SAFETY RECALL NOTICE

2010-2012 Cannondale Bad Boy and Bad Girl Bicycles

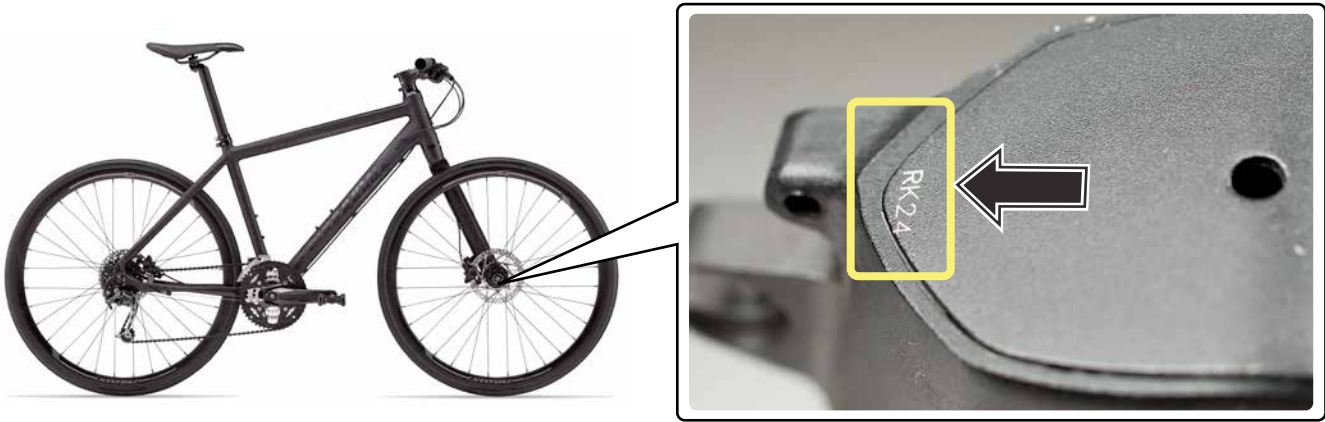
2010-2012 Bad Boy and Bad Girl bicycles subject to recall can be identified by looking at the date code on the bottom of the fork leg. Look for the first character of the code as compare with tables below to find out if the bicycle is subject to this recall.

This recall is a result of some reports of affected bicycles developing fatigue cracks where the axle meets the fork leg. Fatigue cracks grow with use and can result in a broken axle. There is a risk that the axle may separate from the fork leg, with risk of an accident or injury.

If your bicycle is subject to recall, please stop riding and bring your bicycle to your nearest Cannondale Dealer for inspection and fork replacement.
